Executive Director's Recommendation

Commission Meeting: December 6, 2018

PROJECT Franklin Park Rehabilitation 14th and K Streets, NW Washington, DC	NCPC FILE NUMBER 7545
SUBMITTED BY United States Department of the Interior National Park Service	NCPC MAP FILE NUMBER 21.00(70.00)44841
REVIEW AUTHORITY Federal Projects in the District per 40 U.S.C. § 8722(b)(1) and (d)	APPLICANT'S REQUEST Approval of preliminary site and building plans
	PROPOSED ACTION Approve preliminary site and building plans with comments
	ACTION ITEM TYPE Staff Presentation

Approves the revised preliminary site and building plans for the rehabilitation of Franklin Park, located in downtown Washington, DC.

Café – Site Plan Comparison

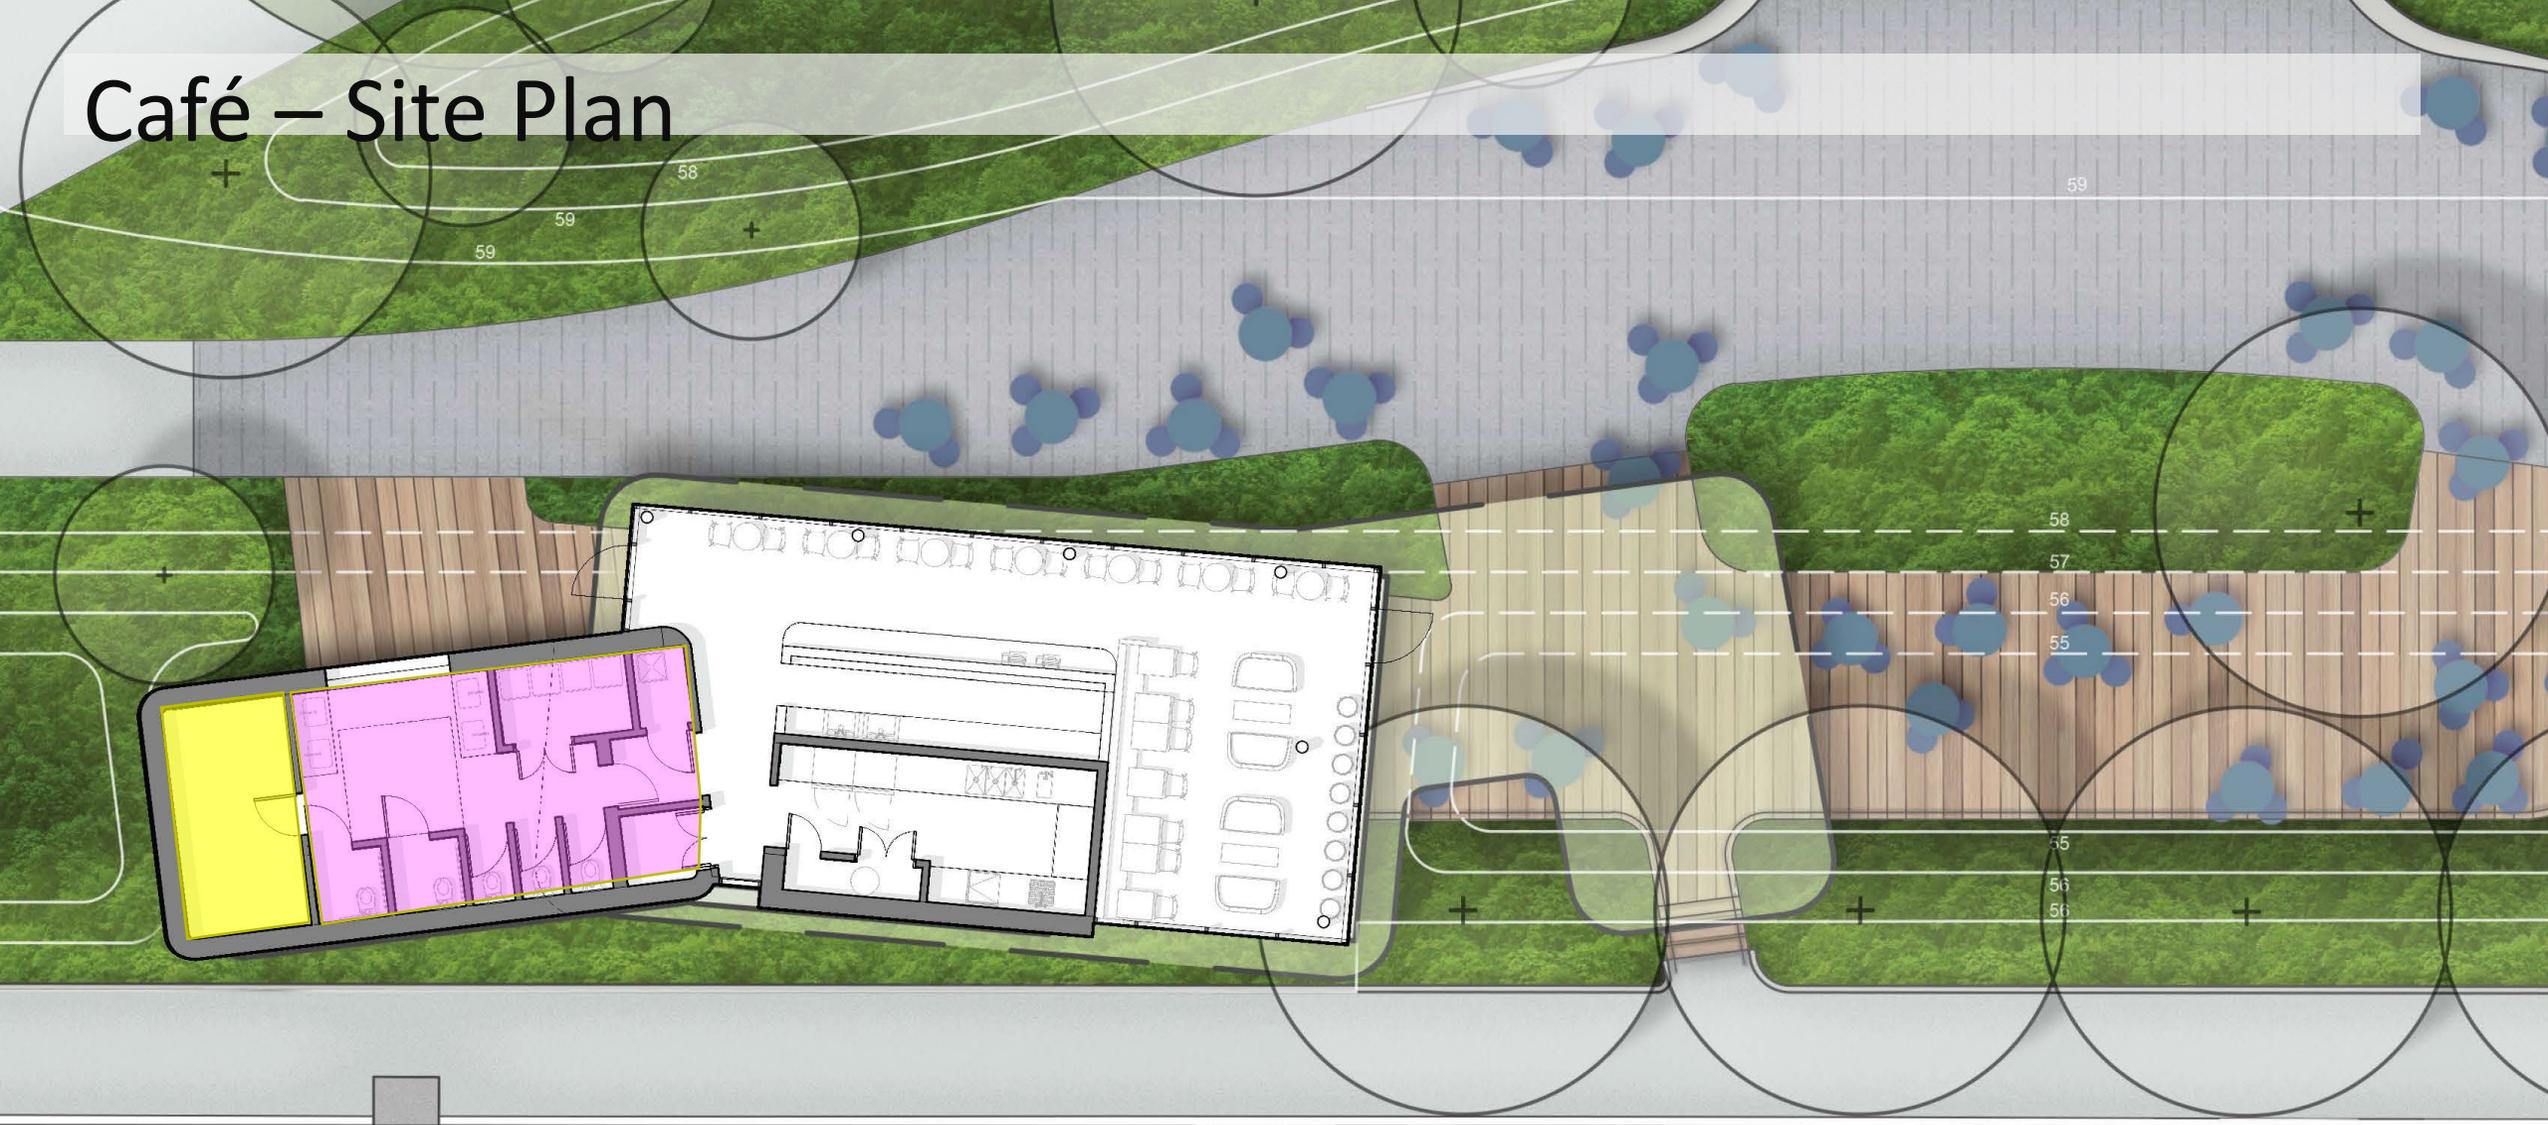
- **Notes** the scale and materials are appropriate and the revised design now allows access to the restroom through the café and from outside.
- **Supports** the design direction of the updated café and restroom building.
- NPS has not included further information of interpretative elements for the pedestrian promenade, and staff **continues** to recommend that these elements be developed in the future.

While the redesigned café/restroom building will be the same size as in the 2015 design, it has been further explored and NPS states it is intended to “float” over the proposed LID that will stretch along the entire southern portion of the park. The café will also incorporate a large canopy that includes a green roof.

Staff has reviewed the revised design and is overall pleased with the direction of the updated café and restroom building. Staff also notes the scale and materials are appropriate and the design now allows access to the restroom through the café and from outside. Finally, staff notes NPS has not included further information of interpretative elements for the pedestrian promenade, which are required under the MOA, but understands that this will be developed in the future.

Children's Garden Recommendations (2015)

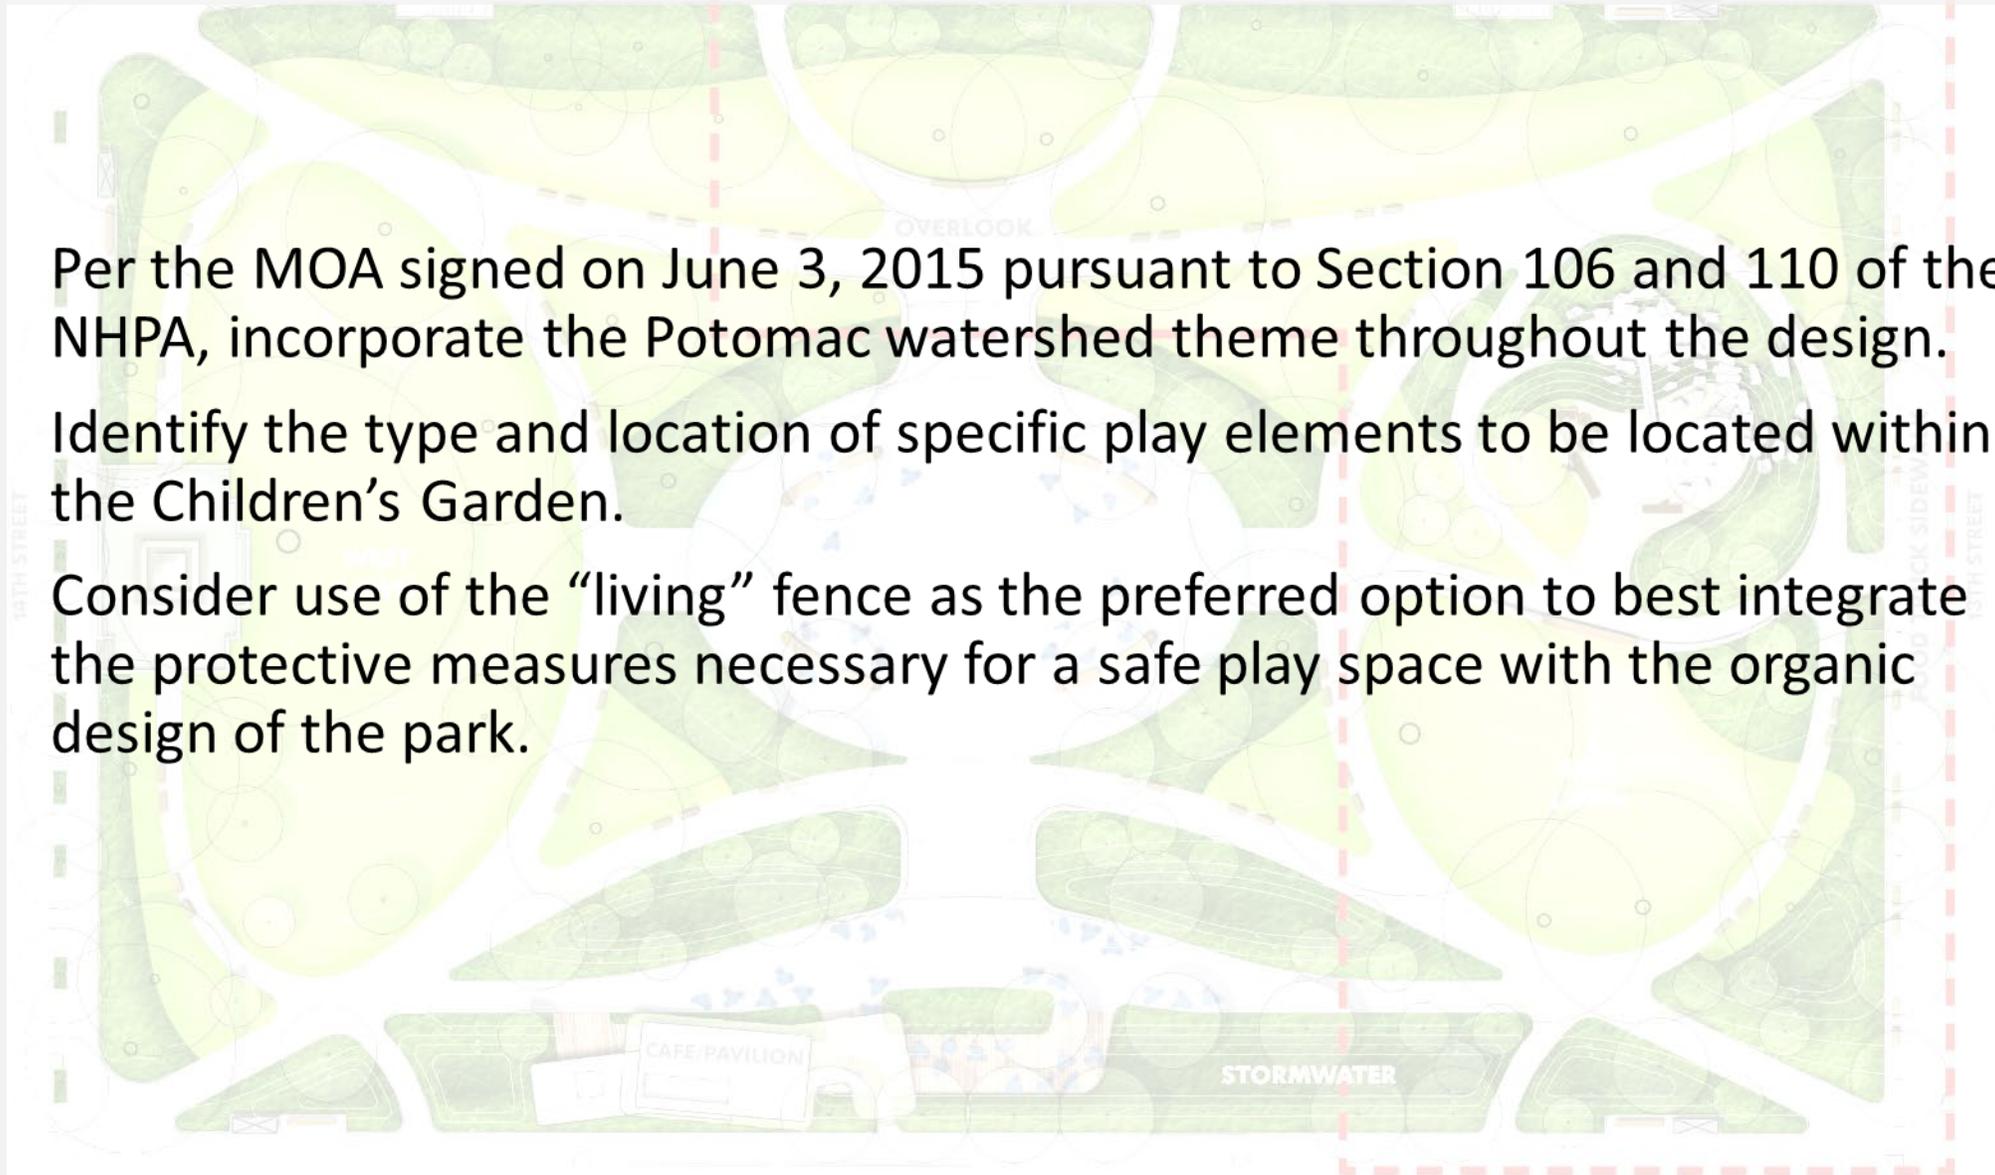
- **Supports** the children's garden as a concept and encourages NPS to fully explore the use of natural materials in creating a unique play space for children.

The current design NPS proposes is a more natural play area that will have small boulders, fallen logs for climbing, and a slide. This design does not include a fence at this time as the proposed topographic changes provide a barrier on the eastern edge of the garden. In addition, parents would be able to sit and keep an eye on their children from a bench located south of the garden.

As this project will introduce natural materials that will encourage interactive play, staff **supports a garden as a concept and would encourage NPS to fully explore the use of natural materials in creating a unique play space for children.**

Option 1 – Existing Condition

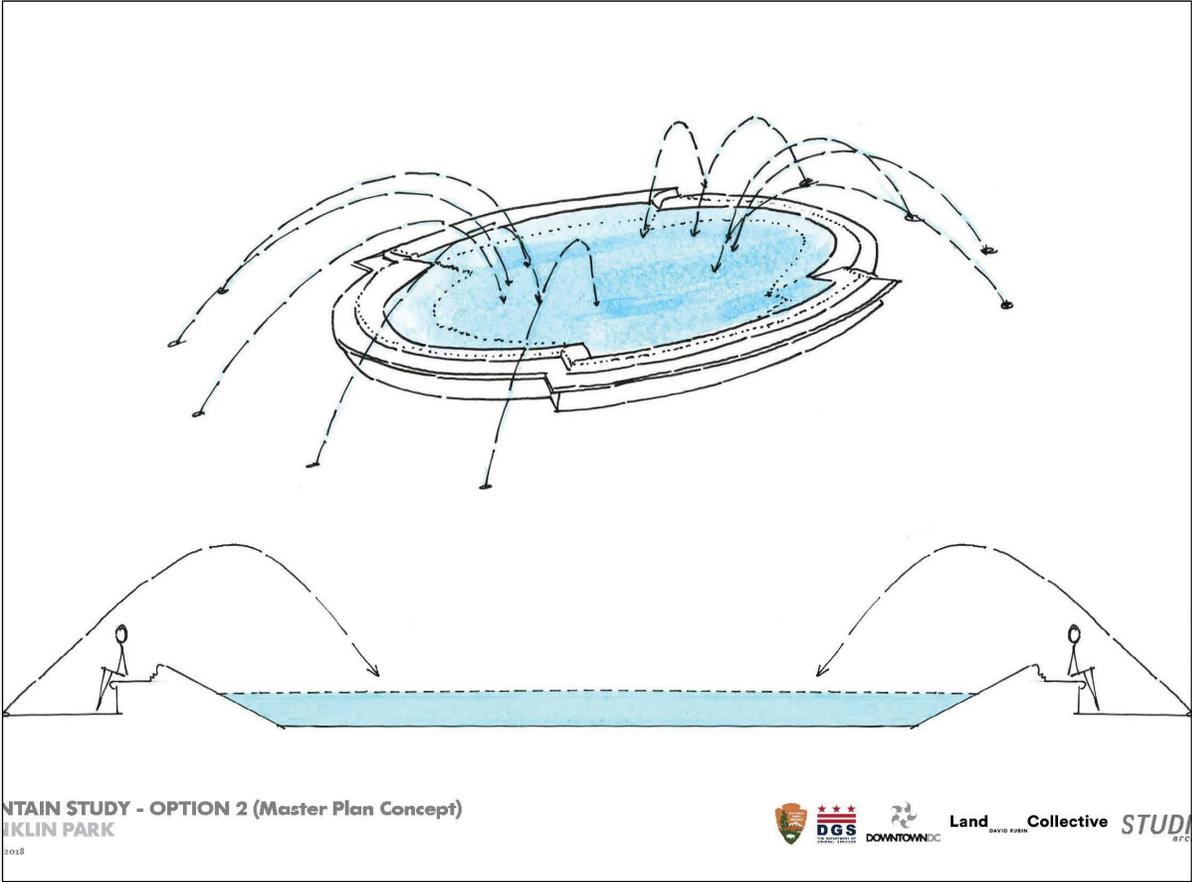
Staff believes these concepts meet the historic preservation criteria by retaining most of the existing coping and fountain bowl with pool and serve as a focal point within the park; however, they are not fully interactive nor would they allow flexible programming in the winter. The scale of concept 1 (existing fountain design) appears small in the context of the proposed larger plaza

with fewer trees. Therefore, staff recommends that the Commission eliminate Concept 1 from further evaluation.

- **Find that concept 1 (restore the existing fountain as is) meets the historic preservation criteria, but does not include an interactive water feature, is less conducive to year-round plaza programming, and is no longer appropriately scaled for the larger plaza and therefore should be eliminated.**
- **Find that concepts 8-9 fail to meet the historic preservation criteria as outlined in the MOA and therefore should be eliminated.**

Option 2

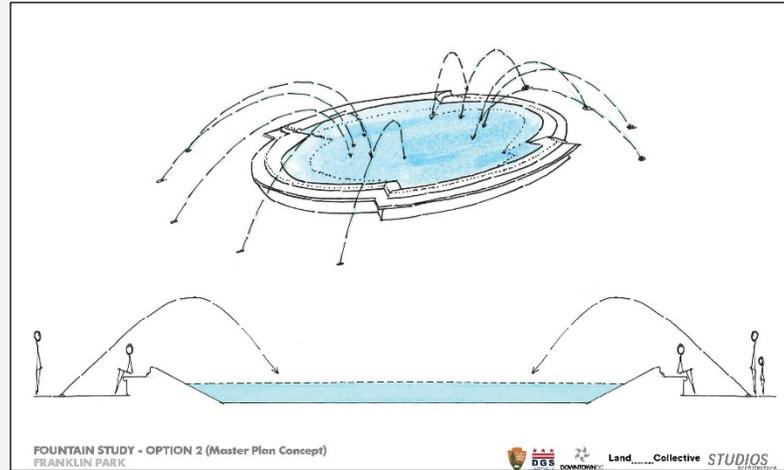
Concepts 1-2 include variations of the fountain design that both retain the original fountain bowl with a pool of water.

- Find that the concepts 2-7 can all be appropriately scaled and designed to include an interactive water feature while maintaining the historic character of the fountain in varying degrees.
- Find that the main difference between these concepts is whether the water feature maintains the pool of water (only concept 2), which differentiates this park from other L'Enfant Plan reservations and contributes to its natural character; or whether the pool is eliminated to allow for more year-round programming flexibility.
- Requests that NPS provide a more detailed explanation of the programming needs for the central plaza, given programming is now proposed for the east and west lawns as well.
- Requests that NPS analyze concepts 2-7 regarding the specific programming needs of the central plaza and whether maintaining a pool with the water feature is feasible.

Requests that NPS analyze concepts 2-7 regarding the specific programming needs of the central plaza and whether maintaining a pool with the water feature is feasible.

Option 4

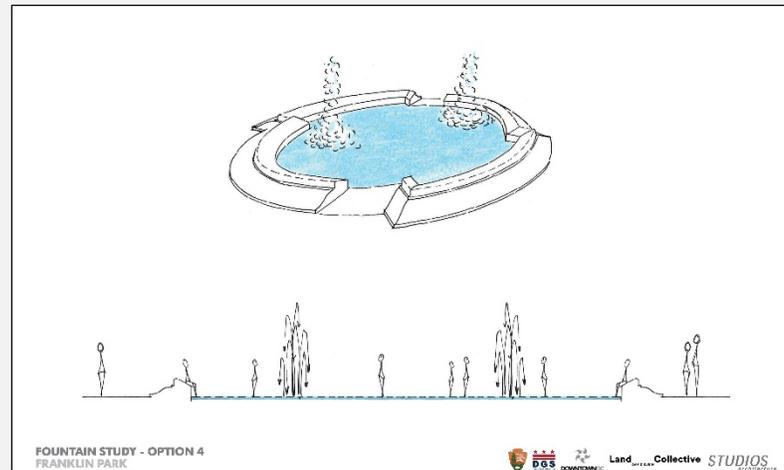
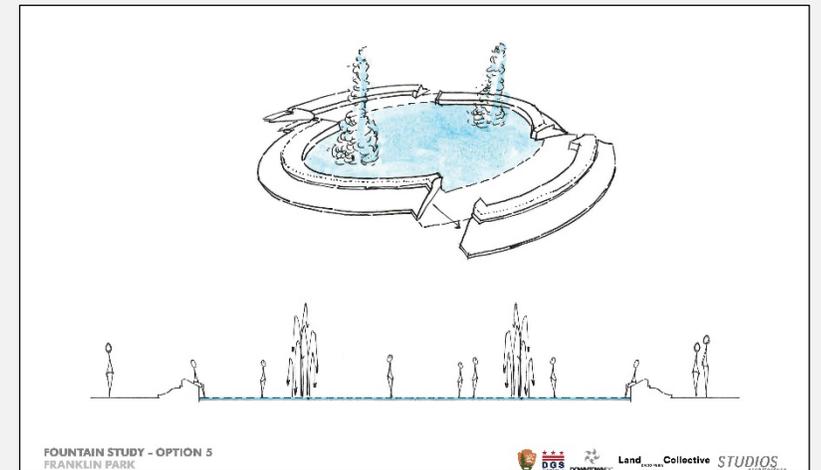
Concepts 3-7 include variations of the fountain design that all retain some or all of the original fountain coping without retaining the bowl and pool of water. The coping would be the only retained part of the fountain. Sprays and a water scrim would be installed to make it more of an interactive feature.

Staff understands these concepts largely meet the historic preservation criteria as they incorporate the existing historic coping into the redesign; however, concepts 5 and 7 are less successful in this regard. All concepts no longer retain the pool of water which has historically differentiated this park from other NPS reservations. The proposed scrim and jets however, will be more interactive for a diverse group of people. Maintaining the existing coping design will create a focal point within the plaza throughout the winter when the water feature is off. Some of the concepts appear larger in scale which may be more appropriate for the larger plaza; however, more information regarding dimensions is needed.

Option 8

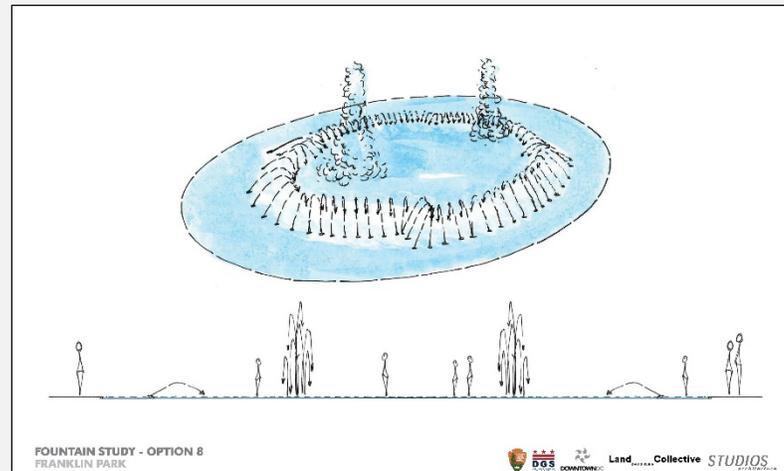
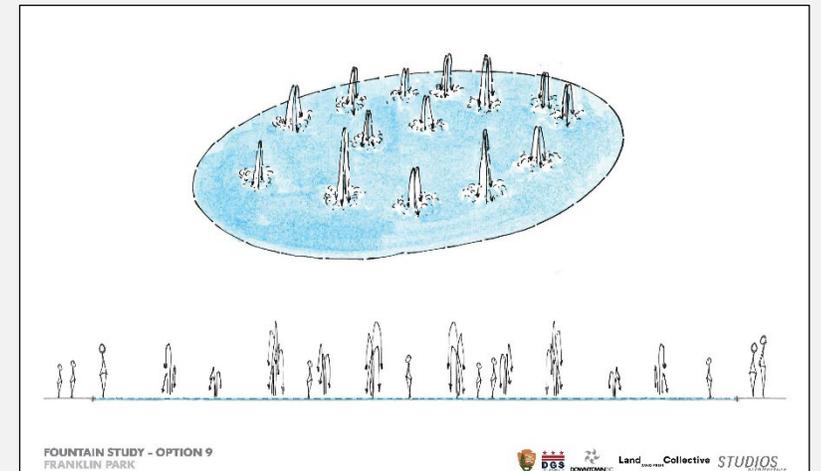
Finds that concepts 8-9 fail to meet the historic preservation criteria as outlined in the MOA and therefore should be eliminated.

Concepts 8-9 include variations of the fountain design that completely eliminate the original fountain bowl with a pool of water. These two concepts include adding water jets and scrim for an interactive element.

While the proposed scrim and jets will be more interactive for a diverse group of people, staff finds these concepts do not meet the historic preservation criteria and the terms of the MOA as the fountain bowl and coping are completely eliminated. These concepts would allow for the greatest flexibility in programming throughout the year as they result in a large open plaza when the water is turned off; however, the role of the fountain as a focal point in the plaza would be gone. For these reasons, staff recommends these concepts should be eliminated.
